20-24 RUSSELL SQUARE

DESIGN, ACCESS AND HERITAGE
STATEMENTS ADDENDUM
2021/2019/P AND LBC

ÉCOLE JEANNINE MANUEL
010222

1 | Proposed Southeast Elevation

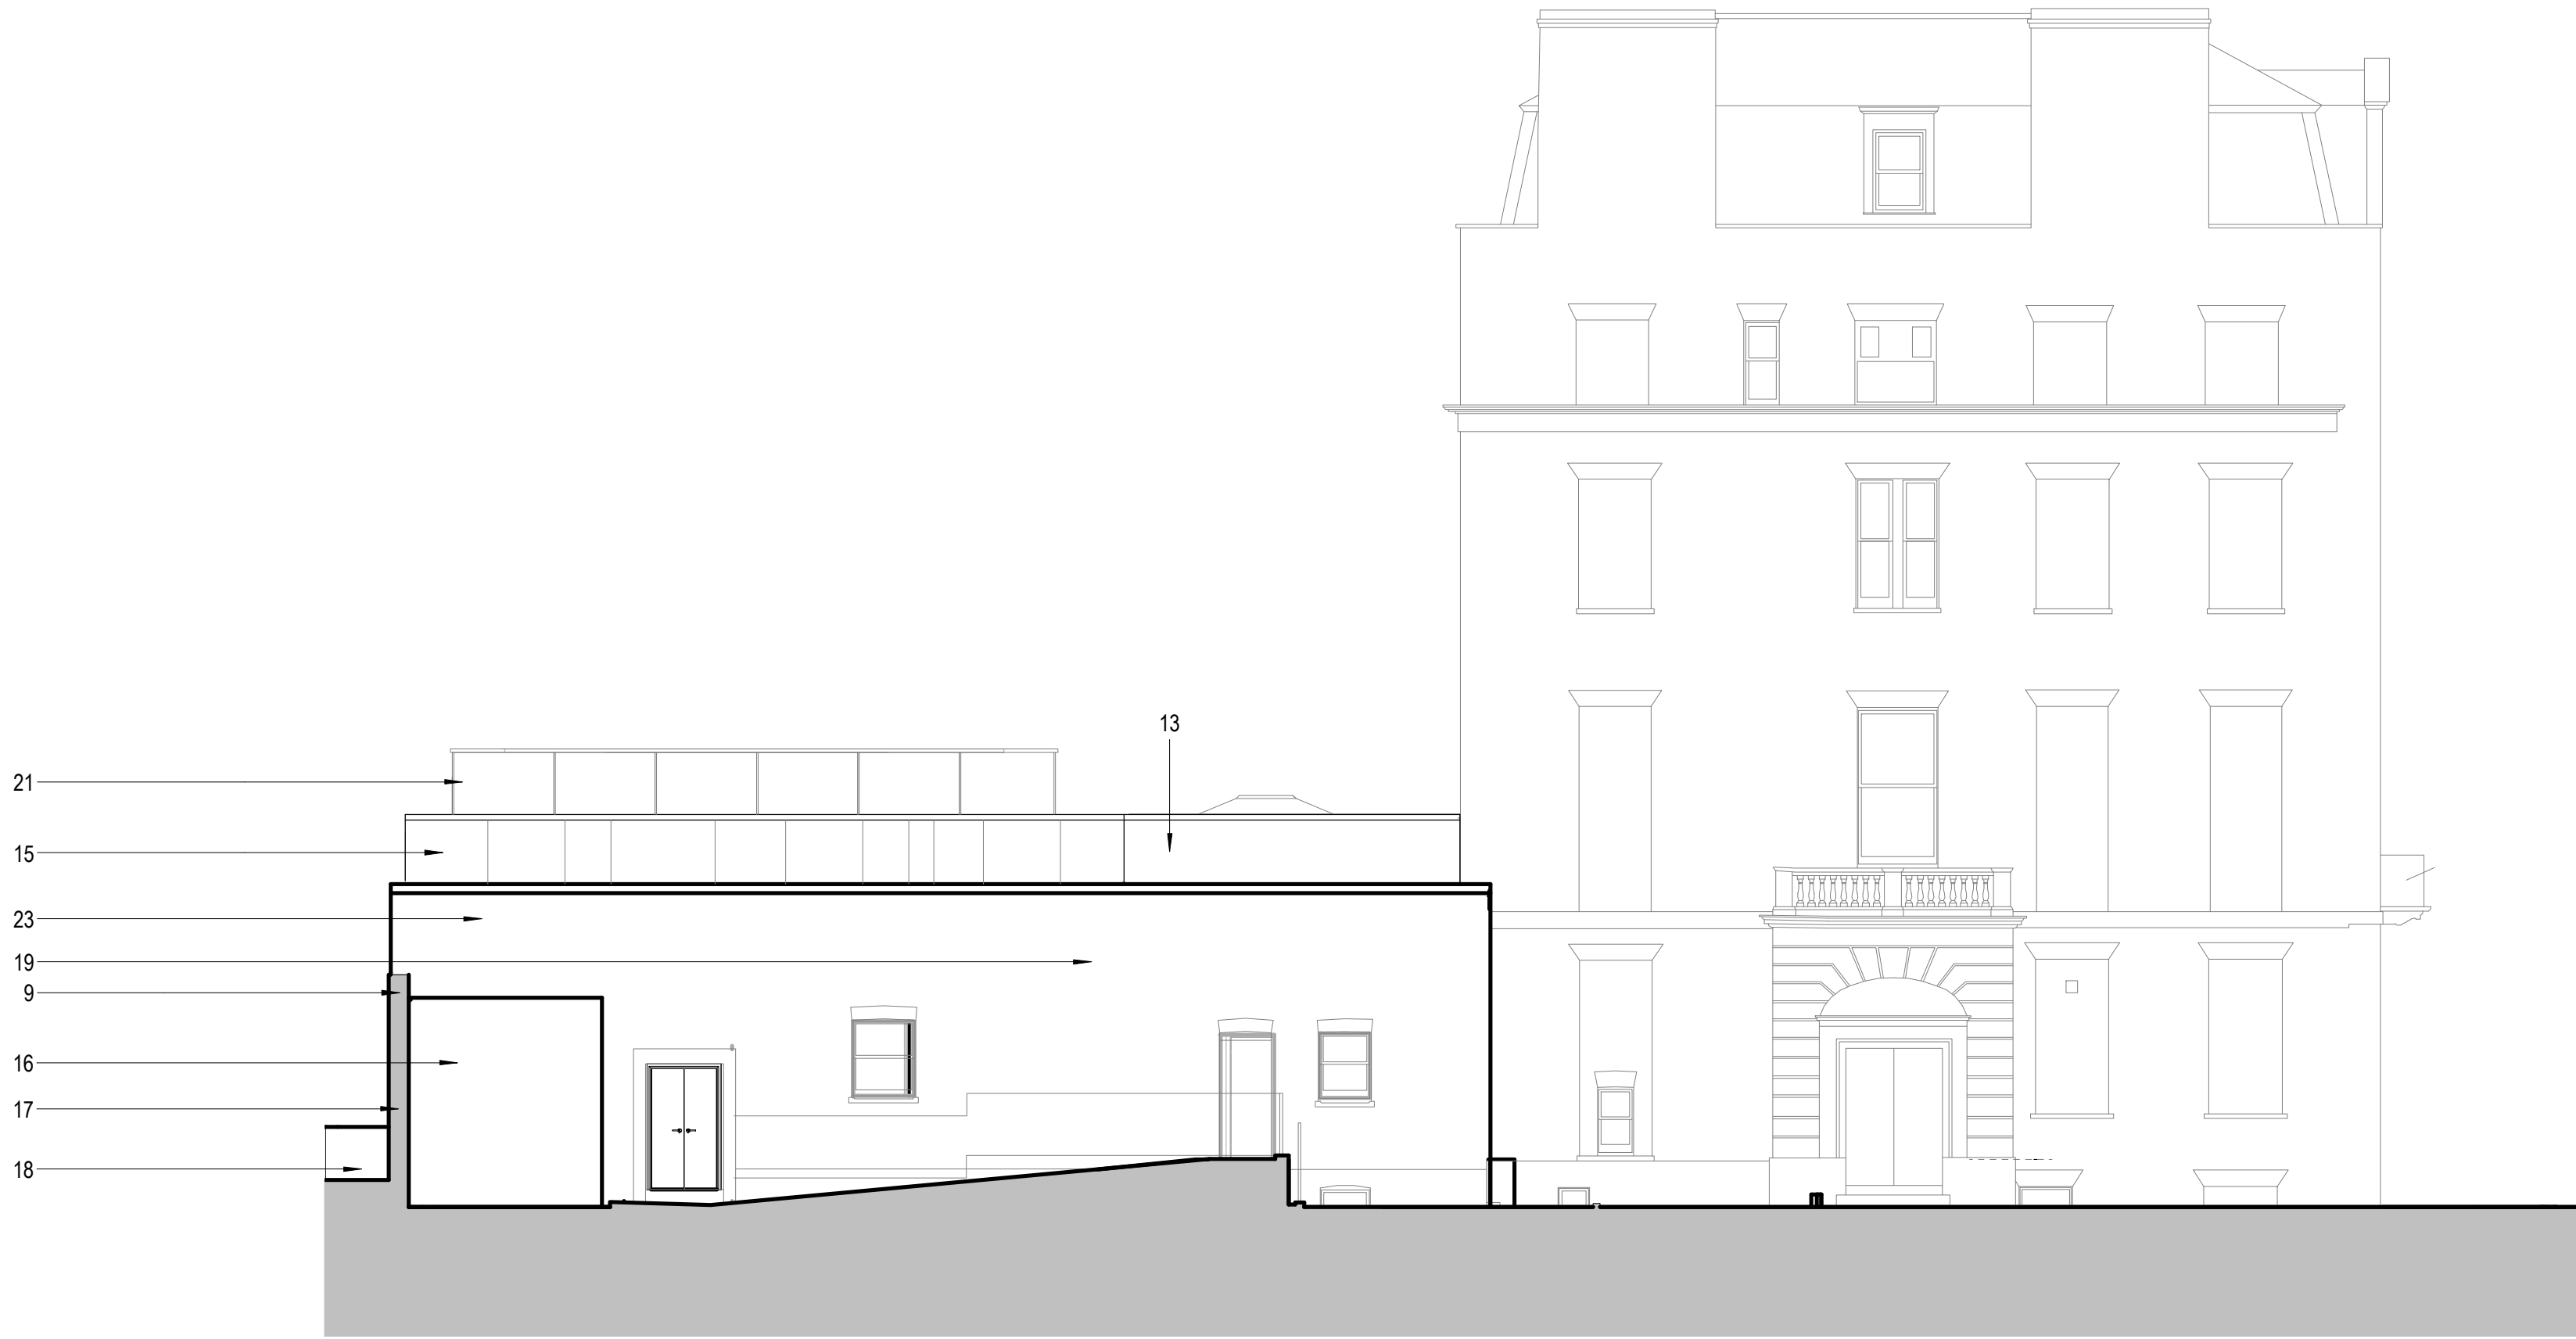
METAL BALUSTRADE WITH GLASS INFILL PANELS TO PERIMETER OF EXTERNAL CURRICULUM SPACE AND BRIDGE CONNECTION REMOVED

20. Proposed timber batten playground fence and gate - refer to Level 0 Plan for location (drawing no: 10401)
21. Dark grey metal balustrade with glass infill panels to perimeter of external curriculum space;

1 | Proposed Southeast Elevation

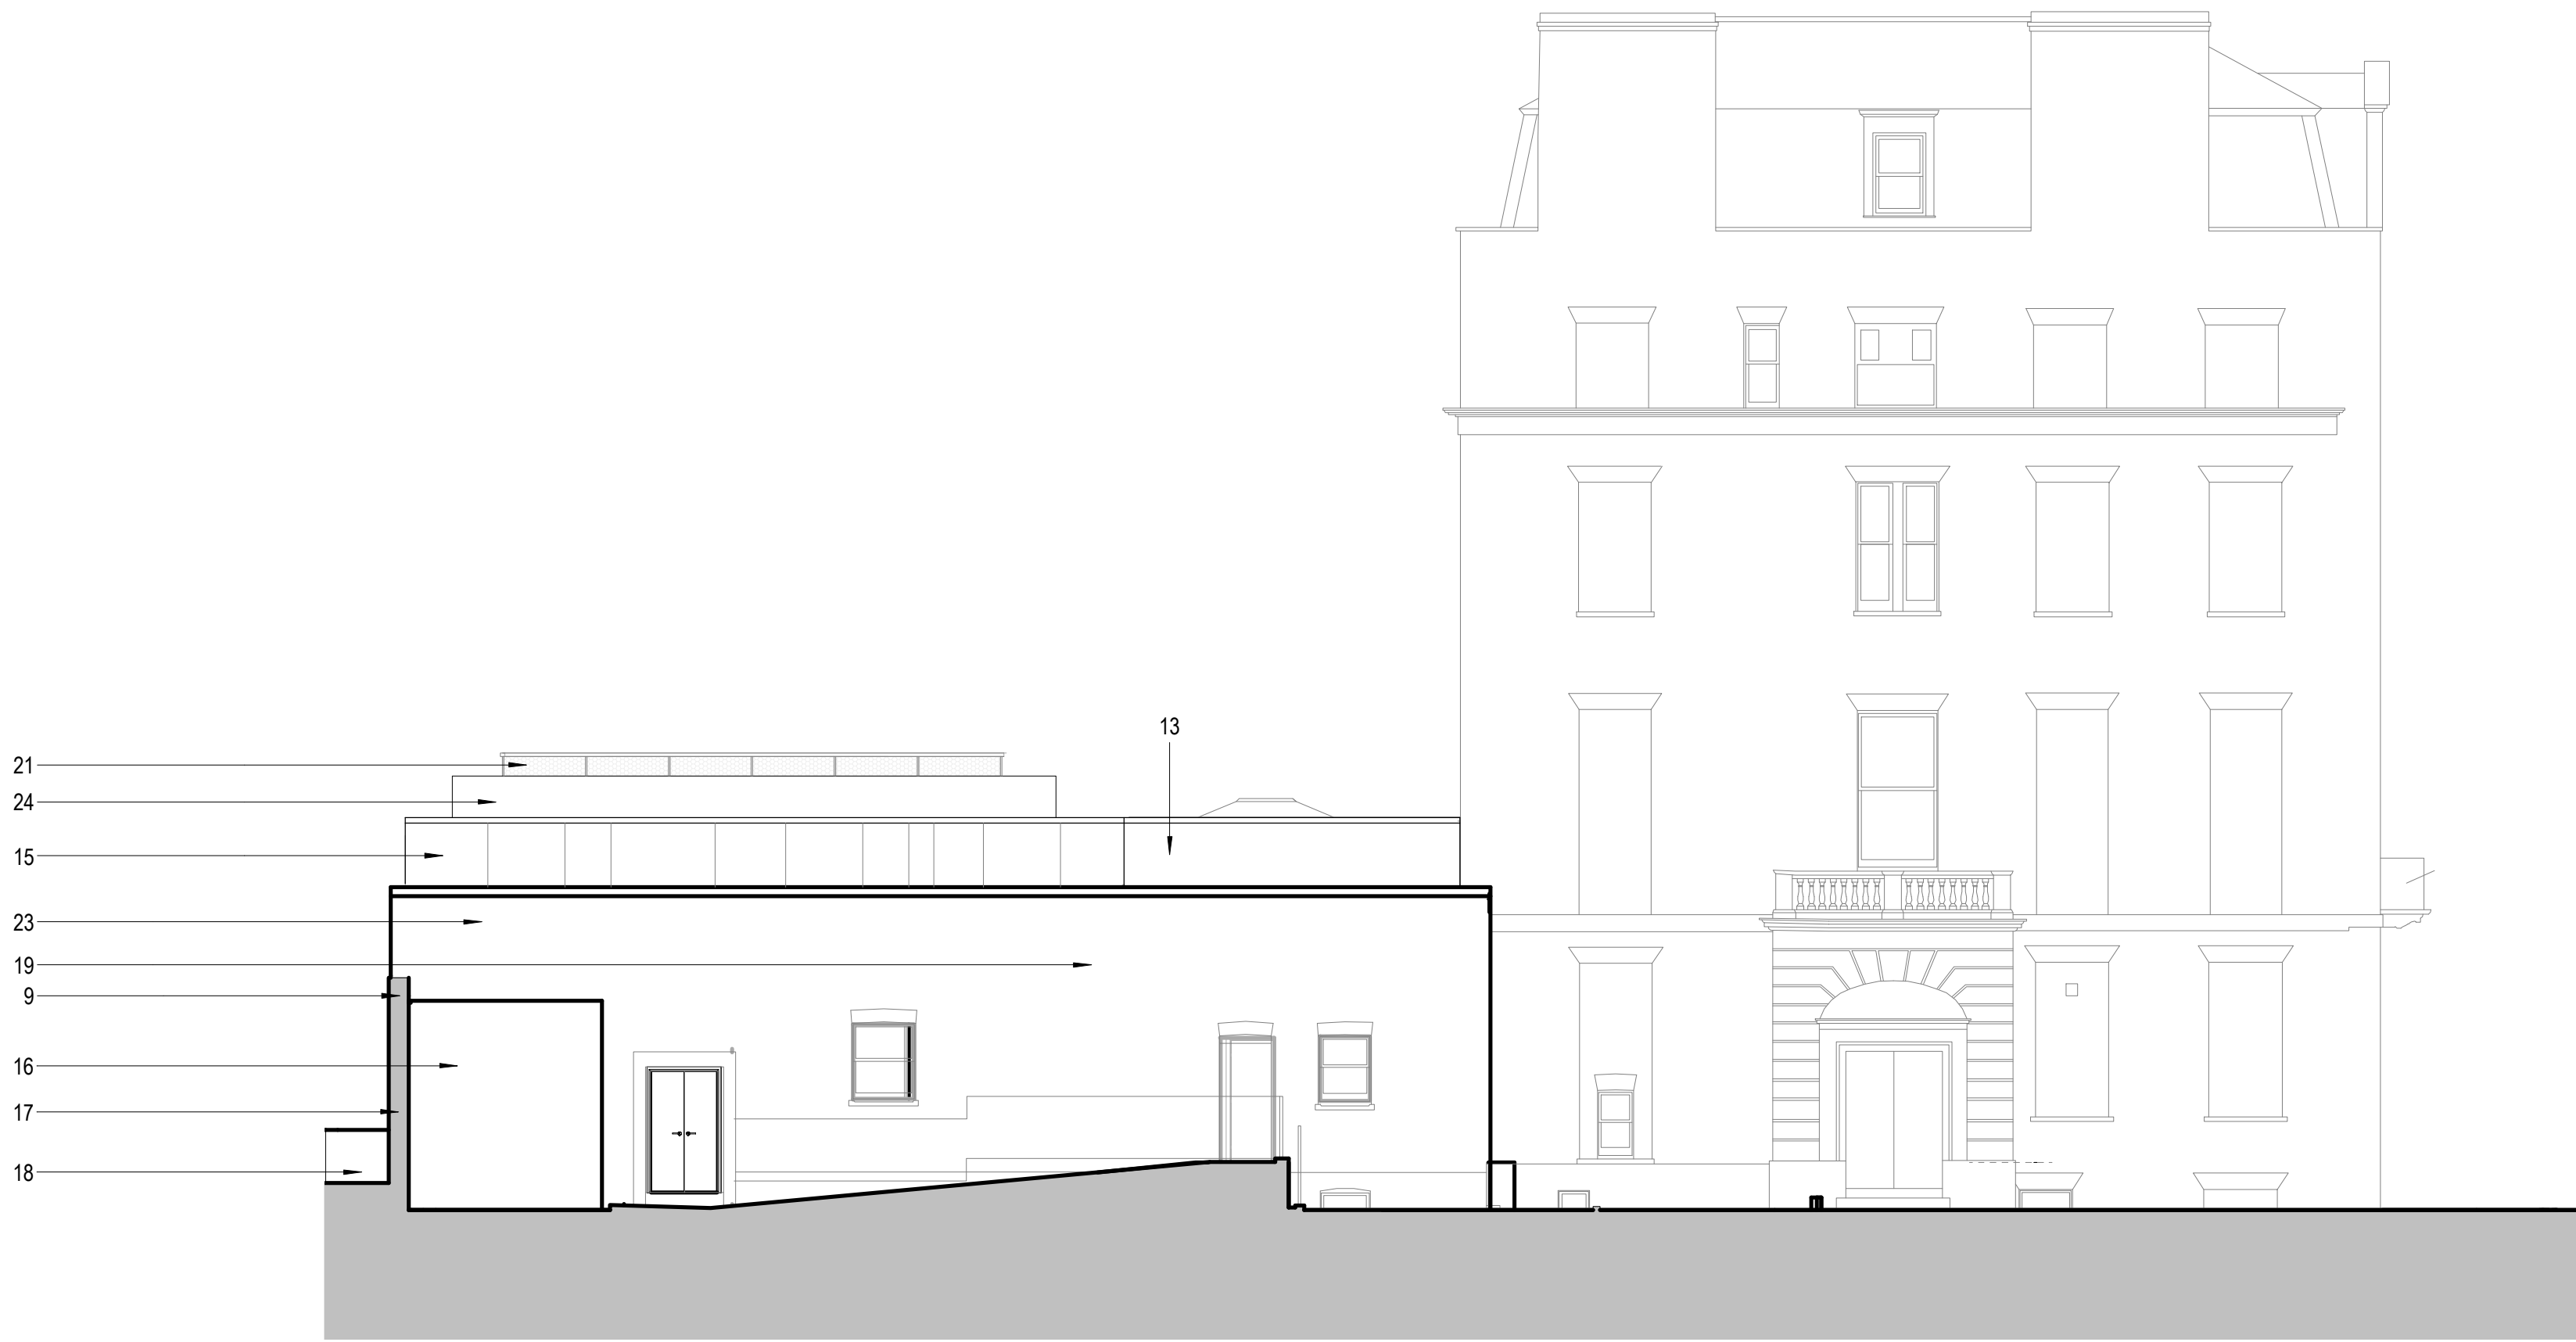
STEEL PLANTER WITH MESH PANELS ABOVE TO PERIMETER OF EXTERNAL CURRICULUM SPACE AND BRIDGE CONNECTION REMOVED

20. Proposed timber batten playground fence and gate - refer to Level 0 Plan for location (drawing no. 10401)
21. Dark grey metal handrail above planter;

Following an assessment of the options and consultation with KM Heritage, we believe Option 4 is the most appropriate design. The revised drawings we have submitted reflect this design. The dark metal planter will sit comfortably in its surroundings matching the metal cladding on the top section of the new Hall and will echo the linear banding and materiality of the IOE. The planter is set back from the parapet and the railing above is further set back which will soften the apparent height of the new extension. The new extension will be of high quality and a timeless design to reflect the listed buildings behind. We found design options 1,2 and 3 to be less successful and have discounted these as they introduce a new material at high level.
